Recall Bulletin

PRODUCT SAFETY RECALL

SUBJECT: Compressed Natural Gas (CNG) Fuel Tank Shut-Off Solenoid Connector

MODELS: 2011-2013 Chevrolet Express
2011-2013 GMC Savana
Equipped with CNG Fuel System

3457040

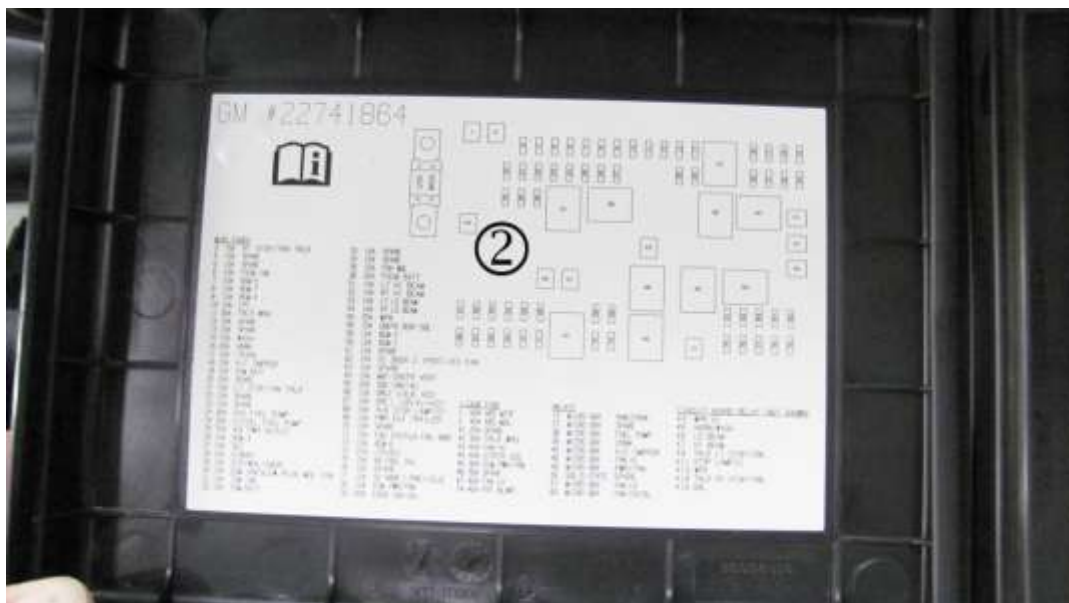
3. Locate the 30-amp fuel pump fuse and remove it from the underhood electrical center or junction block (1). Refer to number 24 on the fuse and relay label, which is located on the underside of the underhood electrical center cover.
4. Discard the 30 amp fuel pump fuse.

- If the vehicle is equipped with a 4-tank system (RPO UFP), install a 7.5-amp fuse.
- If the vehicle is equipped with a 3-tank system (RPO UFM), install a 5-amp fuse.

3457063

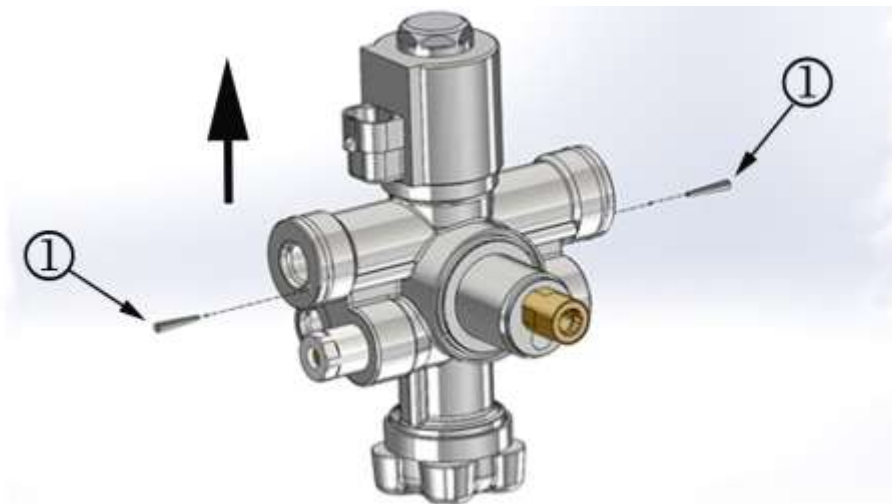
Electrical connector harness shown with no strain on the harness. Note that there is slack in the harness. If the harness does not have any slack, remove the tie strap and adjust the harness. Secure the harness with a new tie strap.

14. Verify that there is no strain on HPL solenoid electrical connector.

- If there is strain on the electrical connector harness, remove the connector tie strap and reposition the harness to relieve the wire strain. Install a new tie strap to secure harness.
- If there is no strain on the electrical connector harness, proceed to step 15.

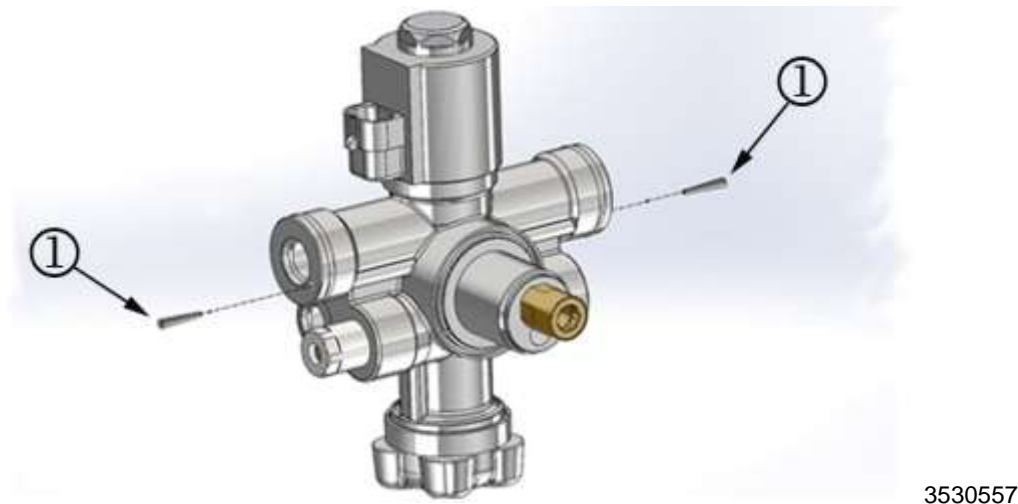
14. Route the forward HPL solenoid harness (1) over the top of brace (2) so that the connector feeds directly into the solenoid.
15. Connect the HPL solenoid harness connector.
